[FI] S.16 Planning Application No. A/NE-TK/832 - Further Information

**1<sup>st</sup> Further Information**

**Proposed Temporary Holiday Camp, Place of Recreation, Sports or Culture  
(Barbecue Site and Hobby Farm) and Eating Place with Ancillary Facilities for a Period of 3 Years  
and Associated Filling of Land in "Agriculture" and "Open Space" Zones and Area shown as 'Road',  
Various Lots in D.D. 17 and Adjoining Government Land, Ting Kok, Tai Po, New Territories**

**(S.16 Planning Application No. A/NE-TK/832)**

**Swept Path Analysis**

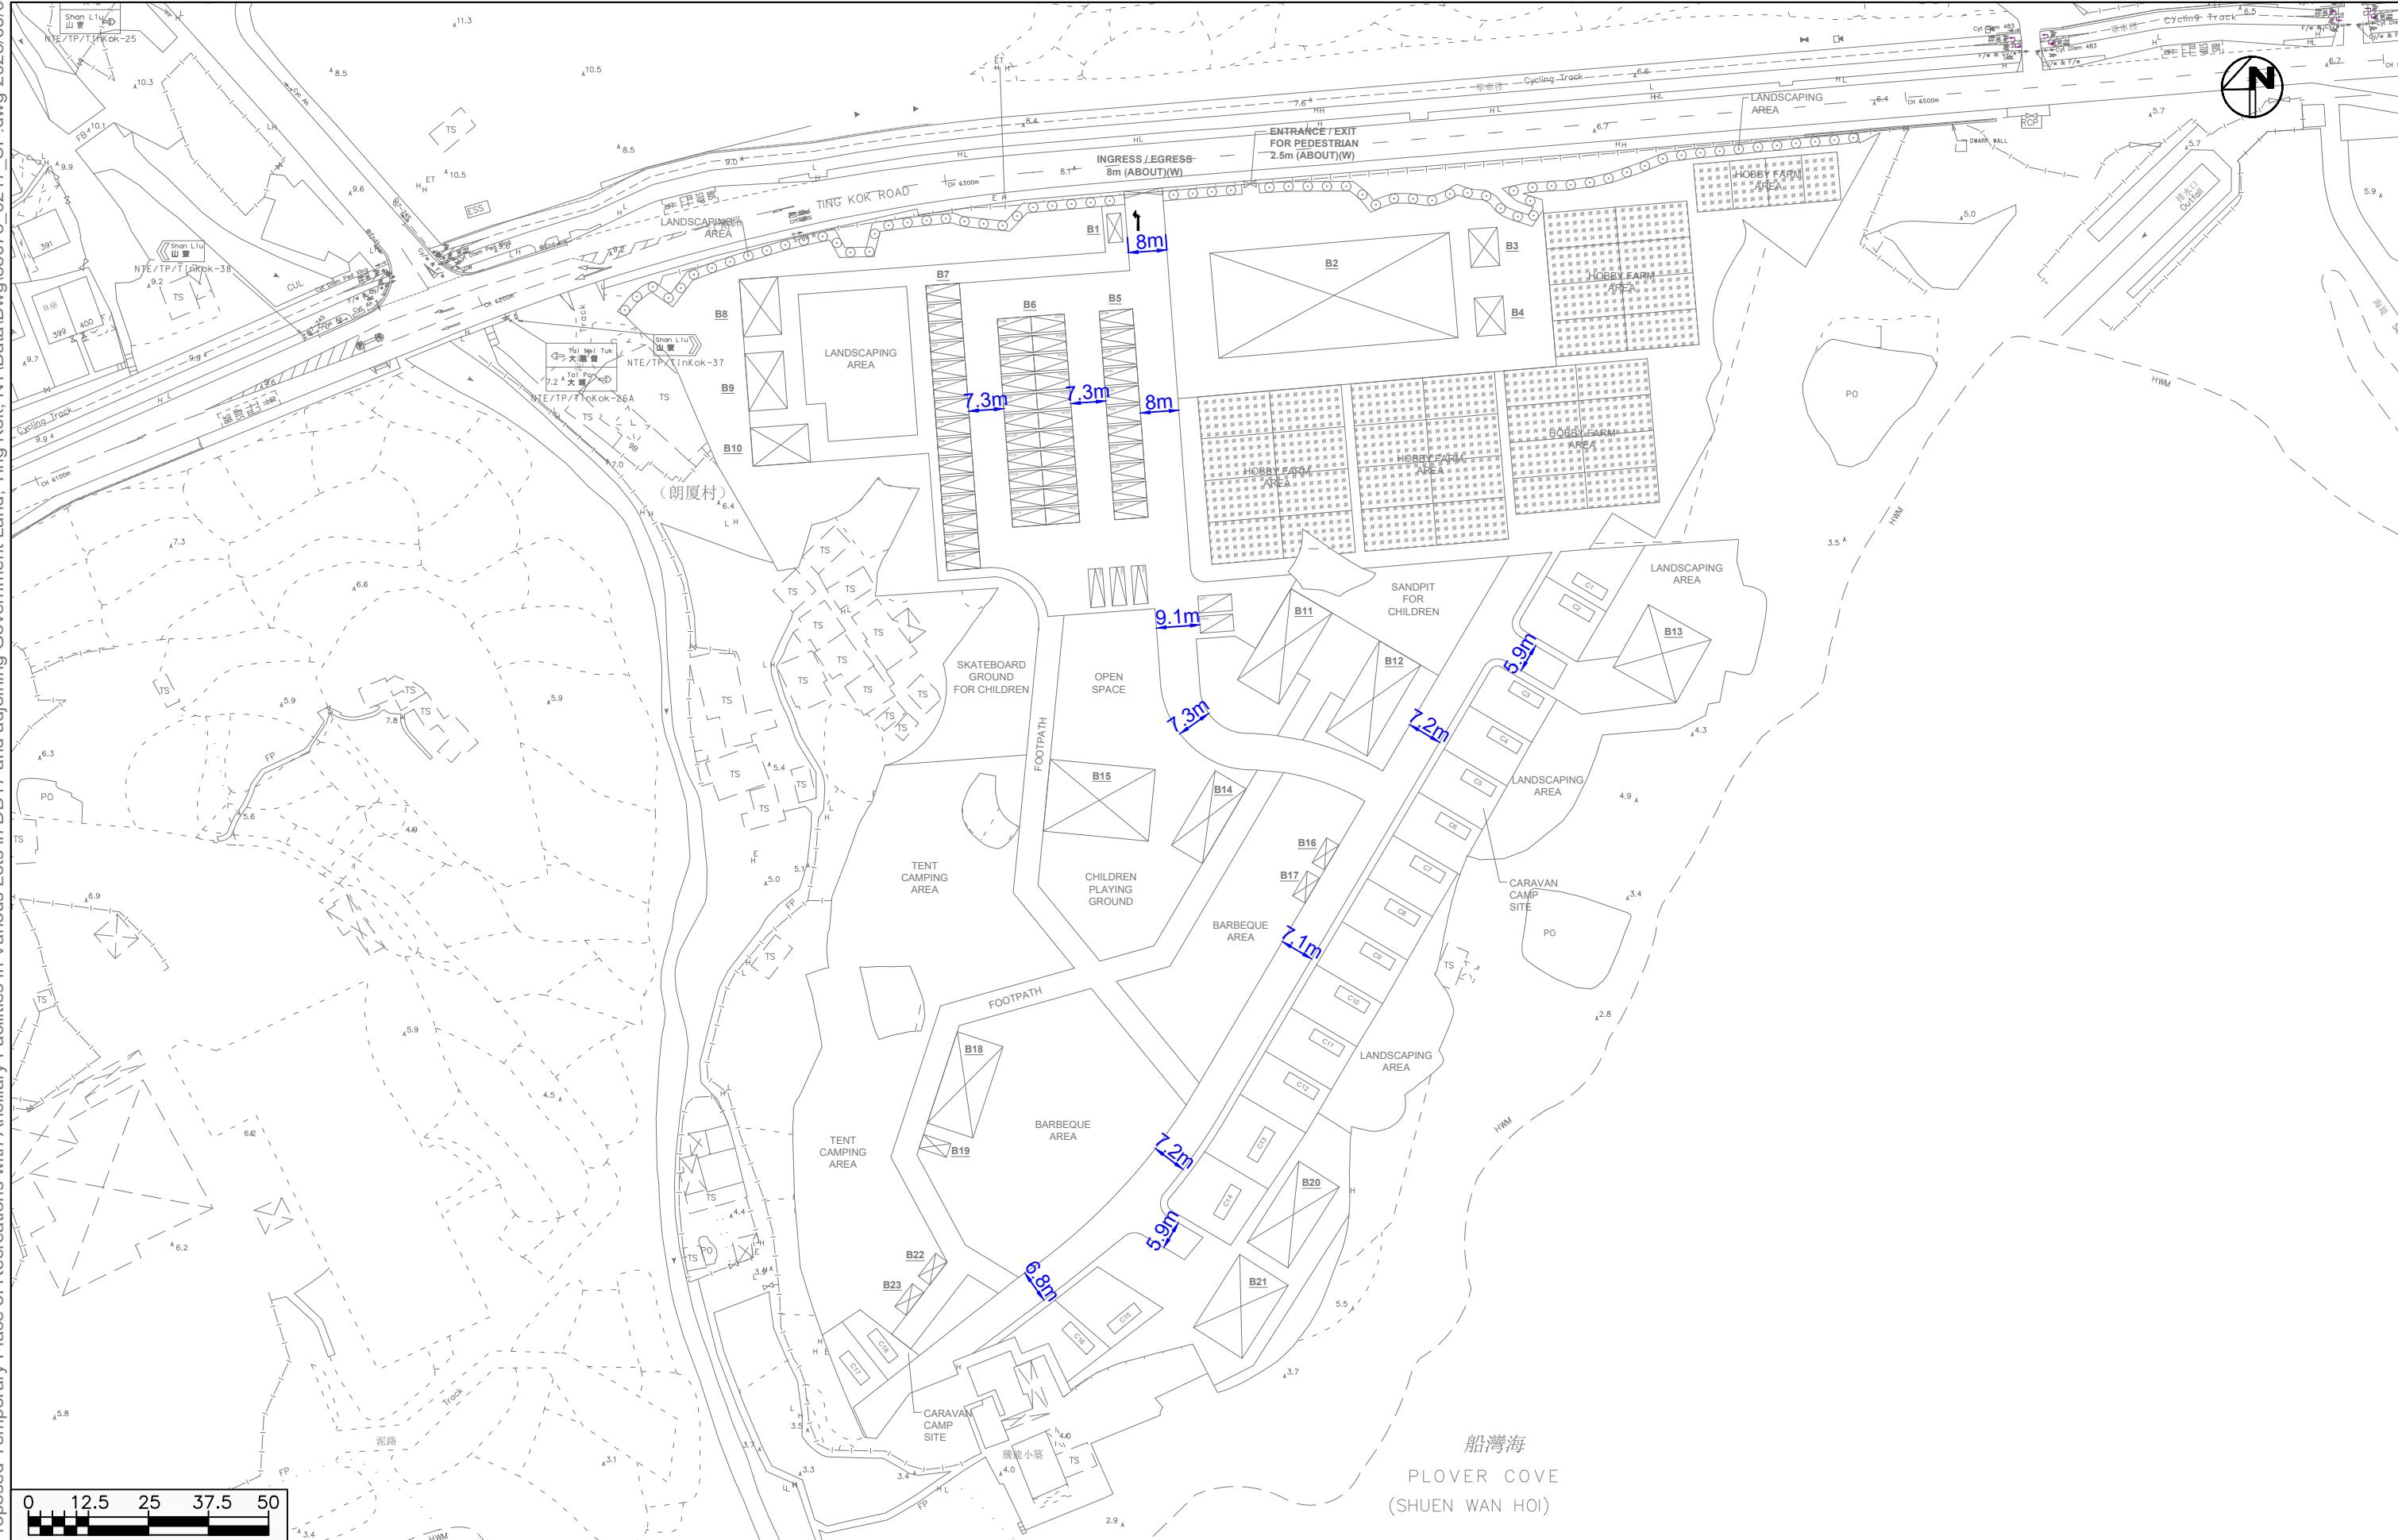
(c)	The applicant shall demonstrate the vehicles can be manoeuvre smoothly to/from the caravan camp sites within the Site.	The swept path demonstration is shown at <b>Annex 1a</b> .

Traffic Sign Proposal

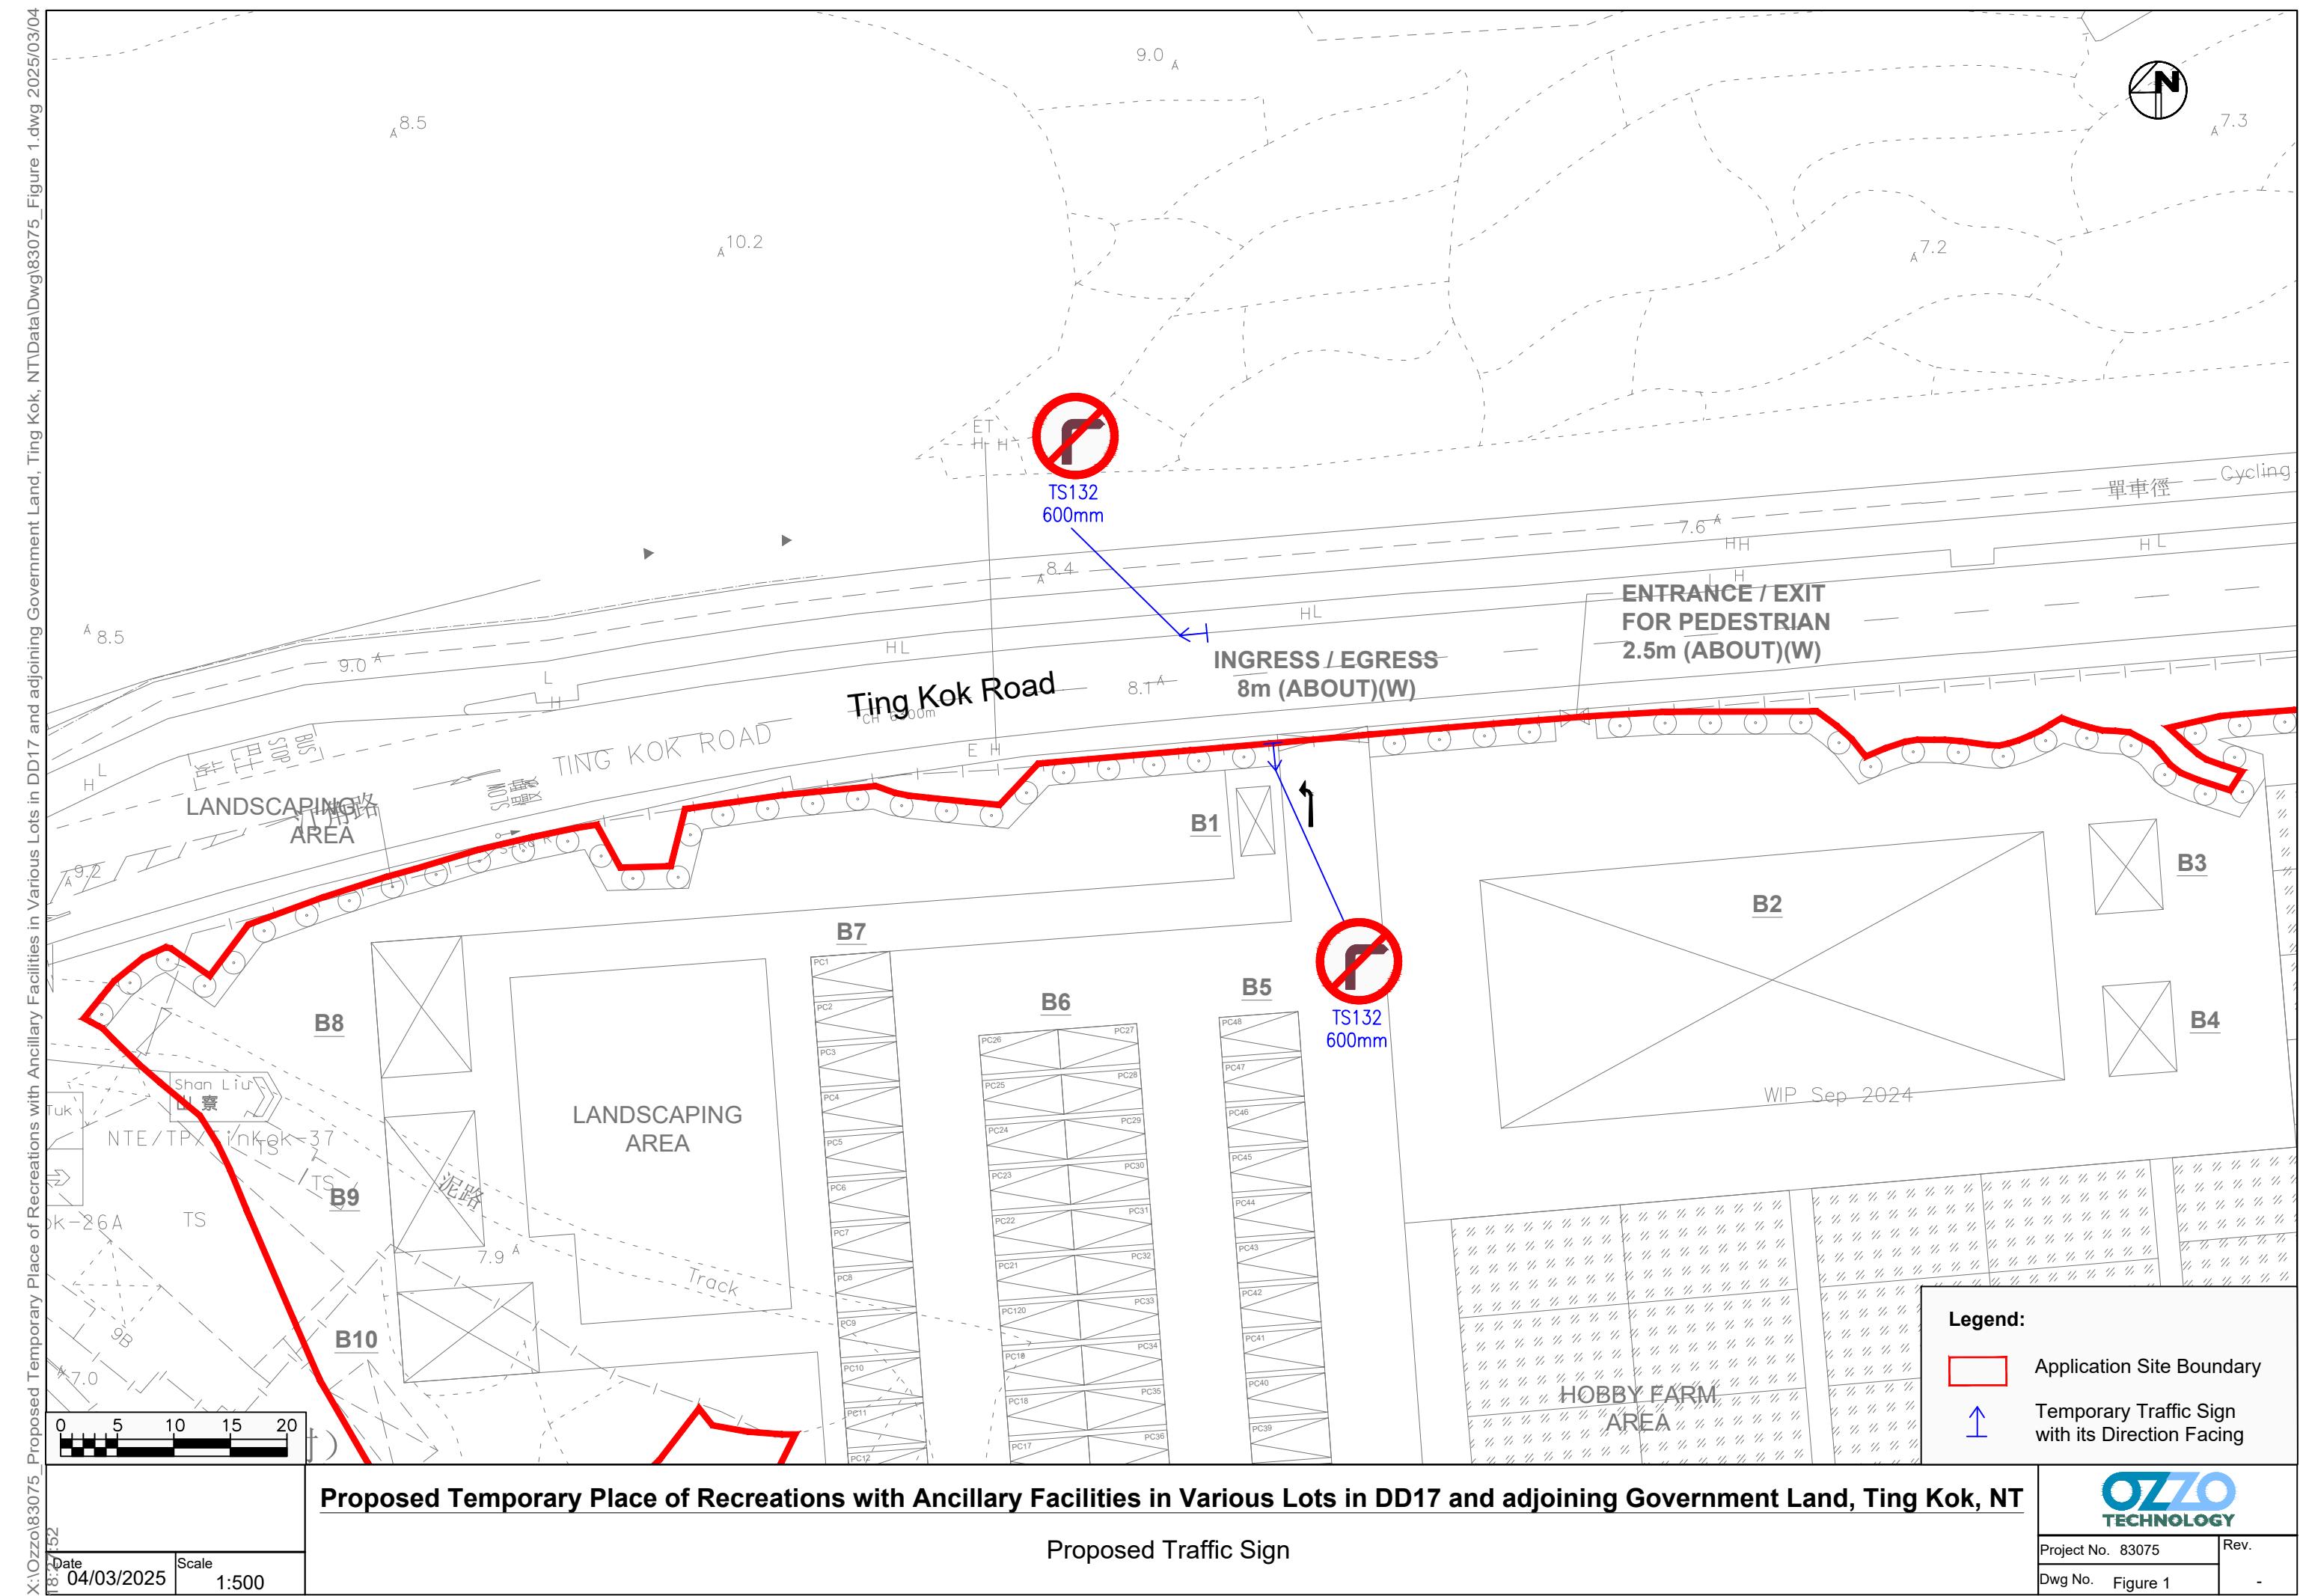
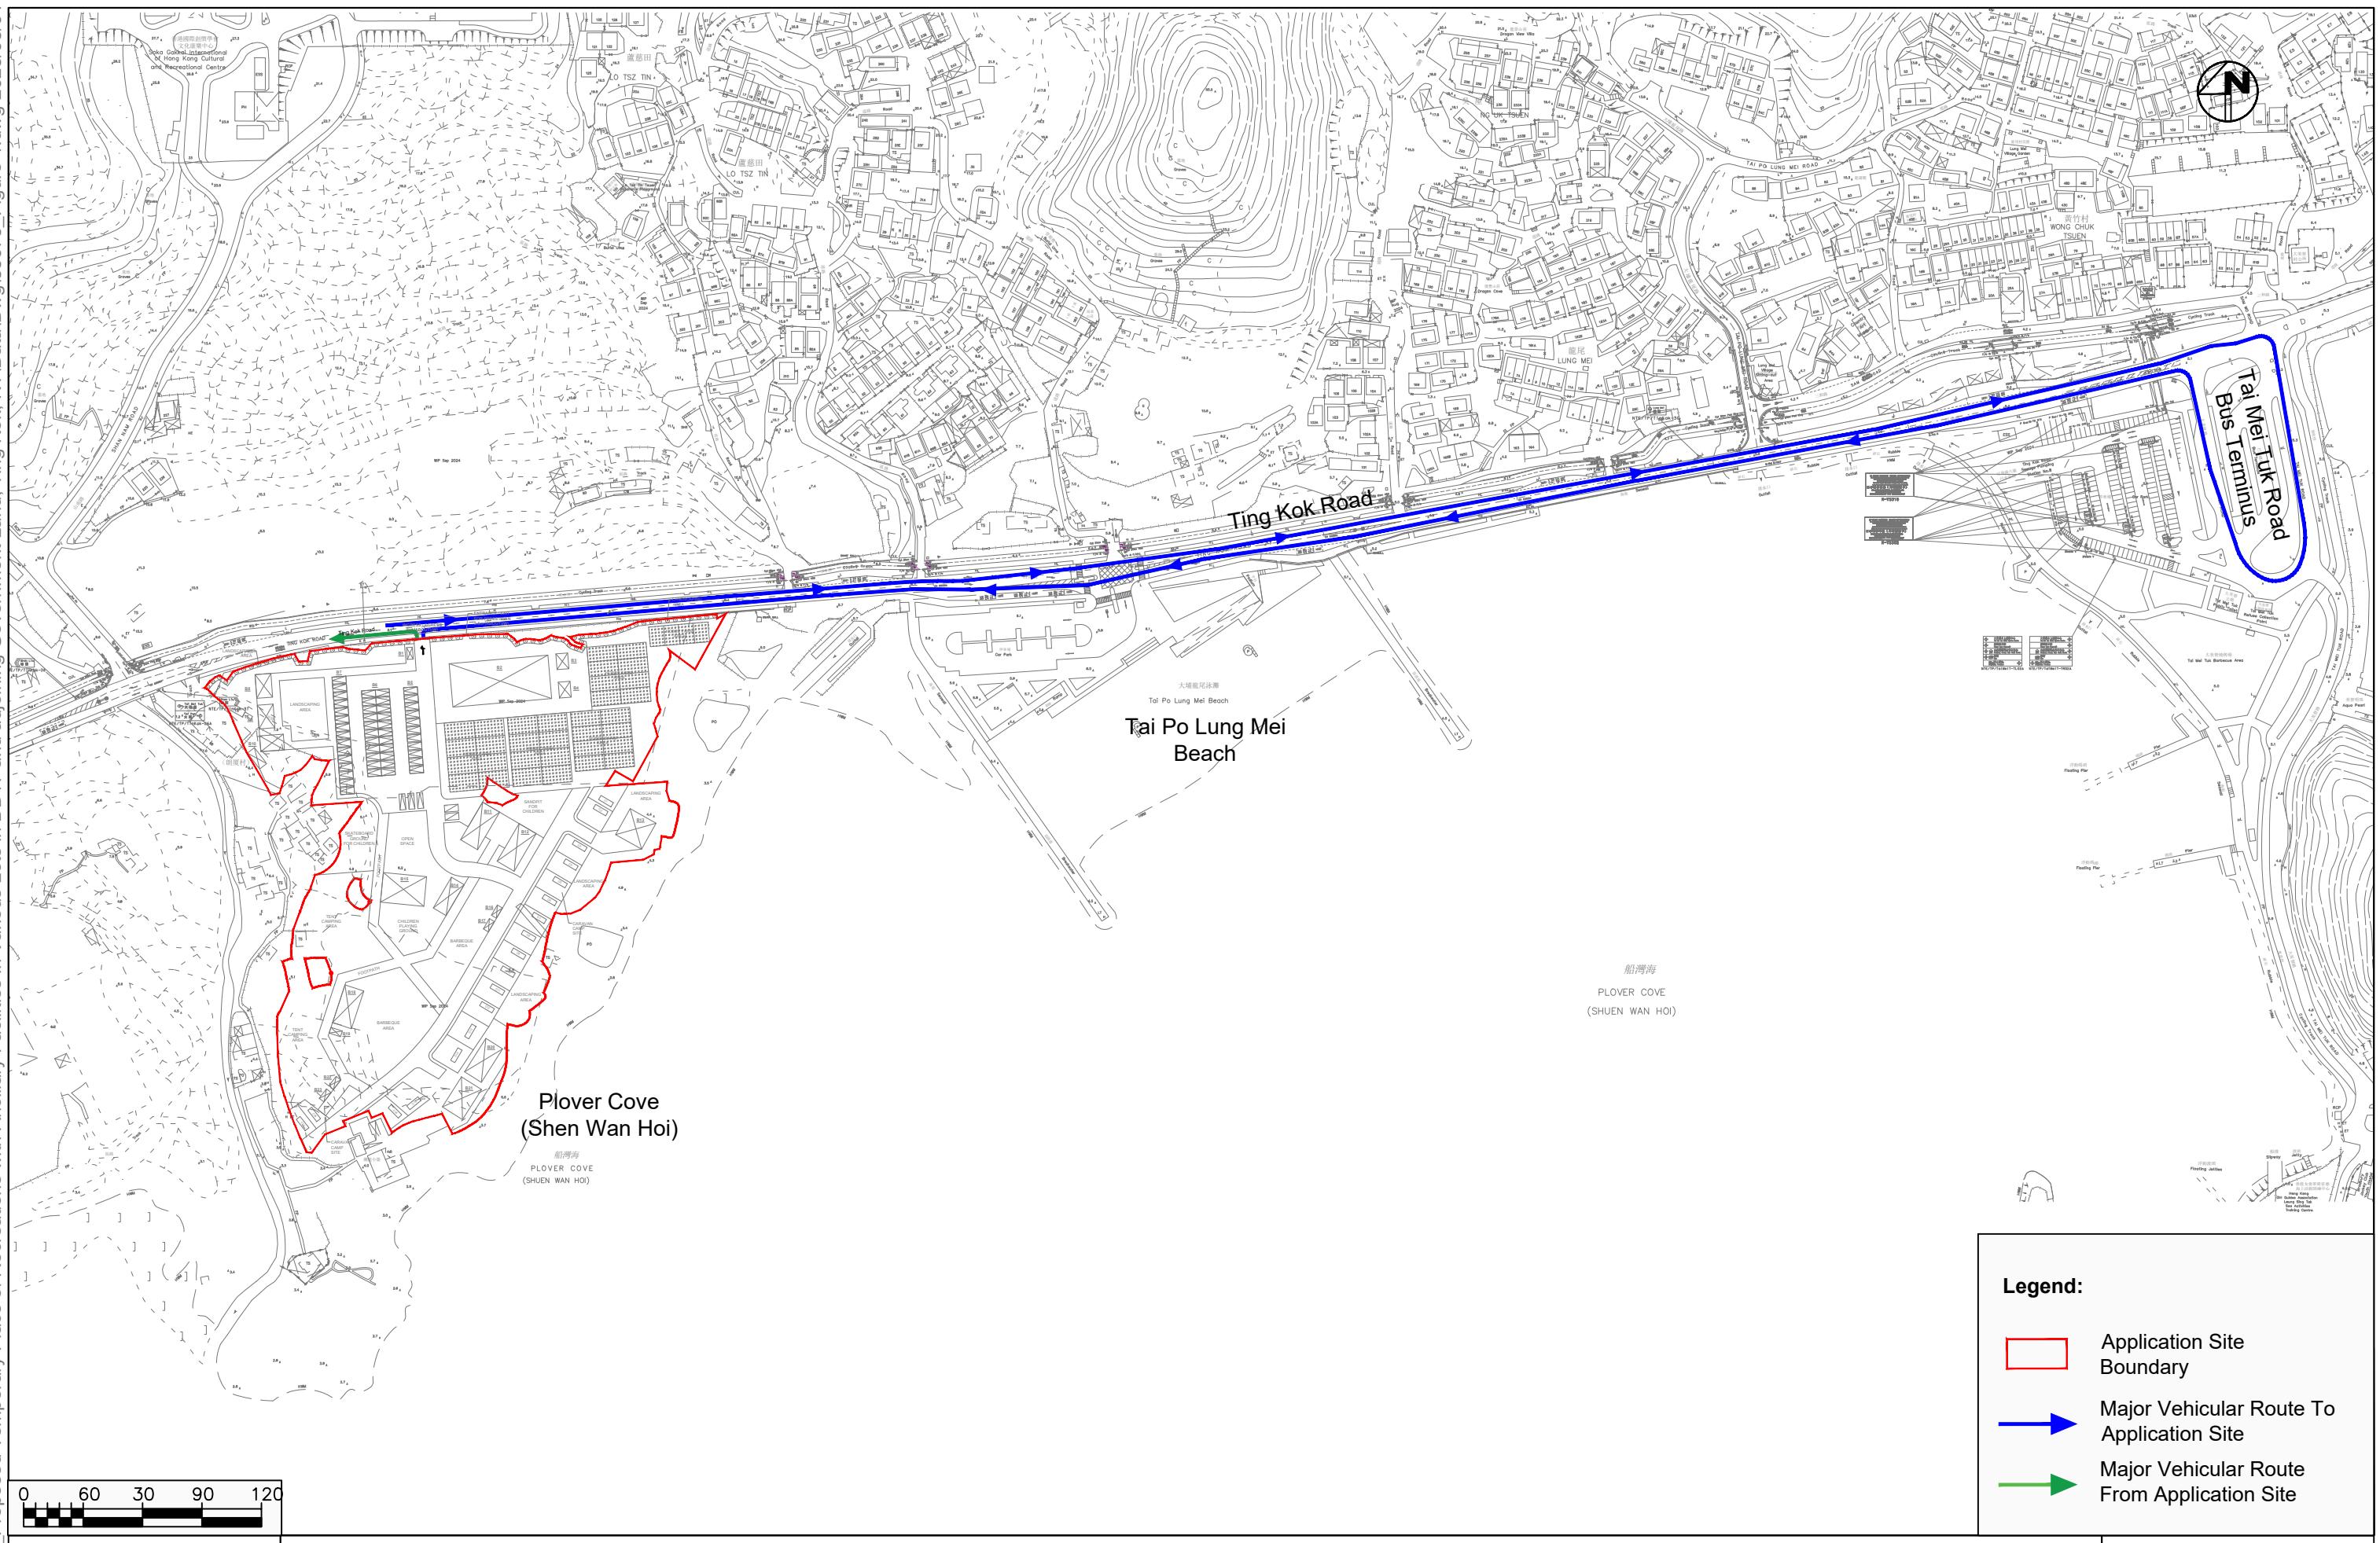
(d)	We received complaints regarding traffic congestion at Ting Kok Road eastbound due to vehicles waiting for right-turning to the access road connecting to the adjacent sites. The applicant shall provide a management plan to mitigate the potential queuing problem on the public road due to the proposed development accordingly.	Right turn from Ting Kok Road eastbound will be prohibited, and traffic signs will be added accordingly. Right turn from the Site will not be allowed. The proposed traffic sign is shown in Figure 1 and Figure 2 at <b>Annex 1b</b> .
